37/3-94F 14 Cleveland Avenue
Takoma Park Historic District

REQUEST FOR PRELIMINARY CONSULTATION

HISTORIC PRESERVATION COMMISSION STAFF REPORT

Address: 14 Cleveland Avenue Meeting Date: 12/21/94
Resource: Takoma Park Historic District Review: HAWP/Alteration
Case Number: 37/3-94F CONTINUED Tax Credit: No
Public Notice: 12/7/94 Report Date: 12/14/94
Applicant: William G. MacRostie Staff: David Berg
PROPOSAL: Construct ell addition, RECOMMEND: **APPROVE**
add side porch **with conditions**

THE ROSSVILLE

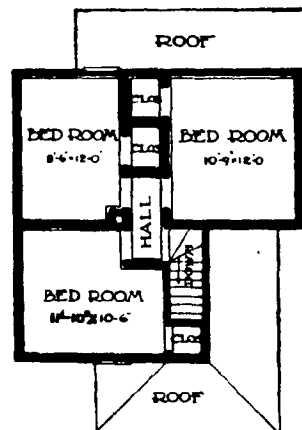
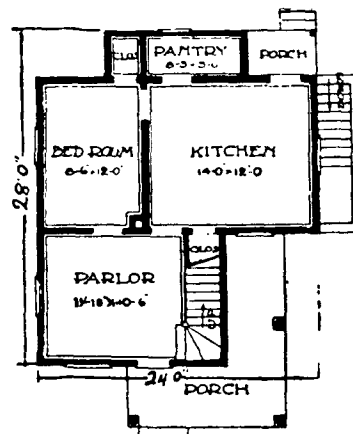
The applicant has also submitted copies of Sears catalog houses that are closer in date to his house (pages 9-11). One, the Rossville, designed for sale starting in 1911, has a wrap-around porch similar to that proposed by the applicant. The other, the Hopeland, first designed for sale in 1921, has strong gable returns like the applicant's house, but the front door is on the ell and the porch encloses the area in front of the ell. Both of these ell forms are longer in relation to the main body of the house (refer to the plans) than the Queen Anne-style examples, and it is clear that these two Sears models are related to the applicant's attempt to integrate the proposed new work with the existing house.

Other Main Block Plus Ell Houses

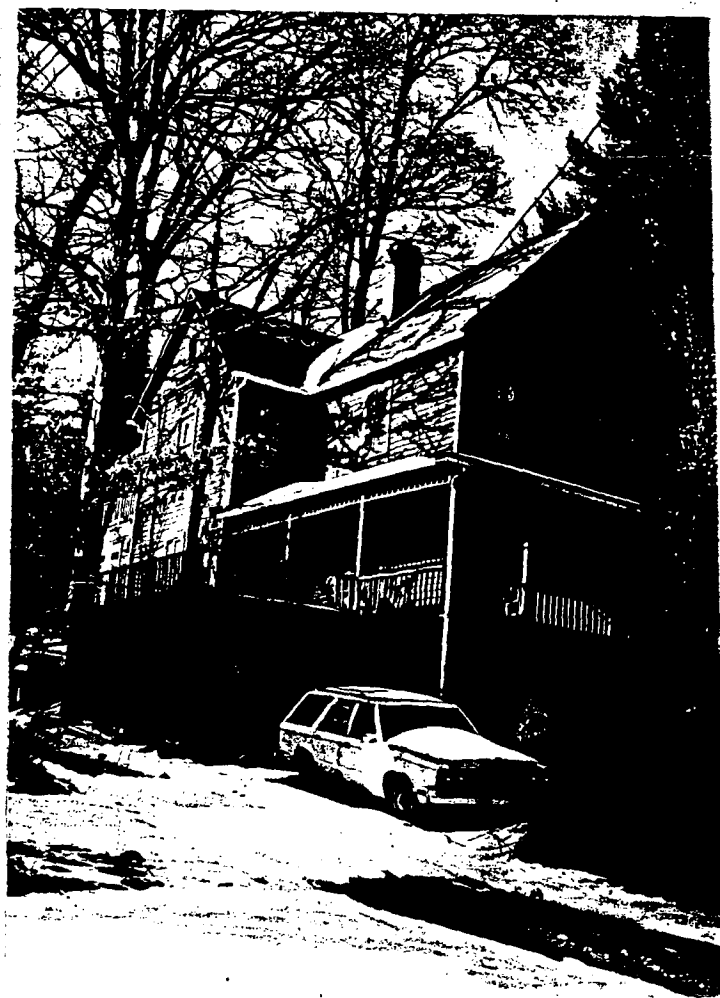
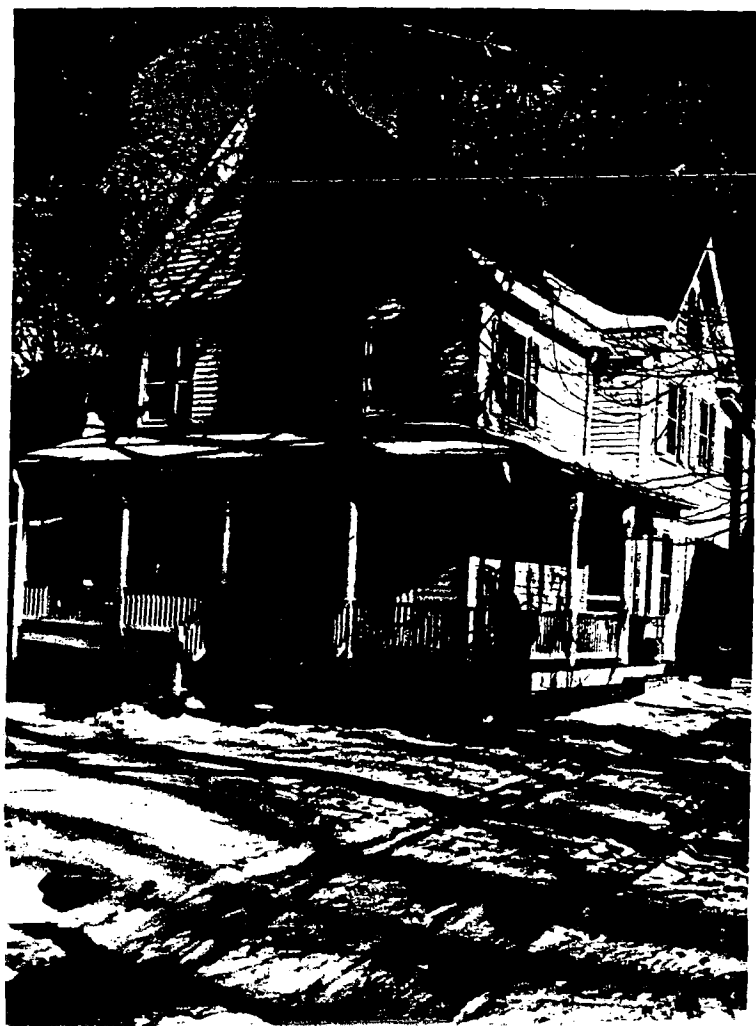
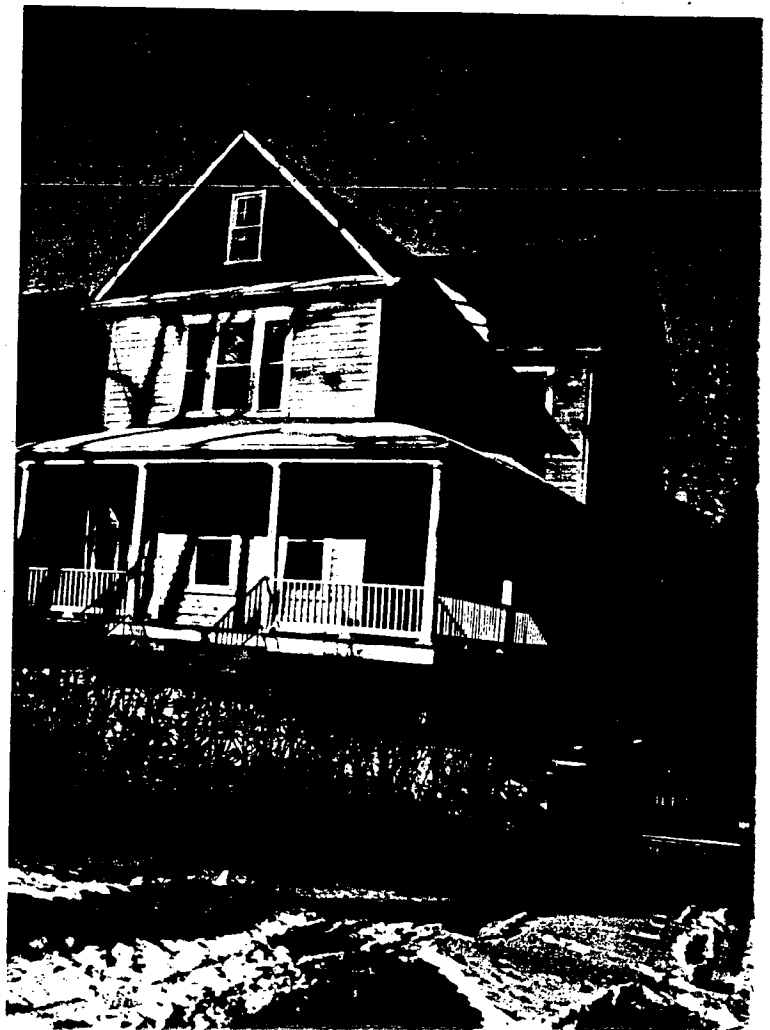
The applicant has submitted photographs of other historic houses in Takoma Park that have an L-plan or cross-gable plan with a connecting wrap-around porch (pages 7-8 of the packet). The staff notes that these houses are all earlier in date and style and are typical of Queen Anne-style houses in both form and plan. Again, the ell forms are much smaller and less significant in these examples, and are only one bay wide, in fact.
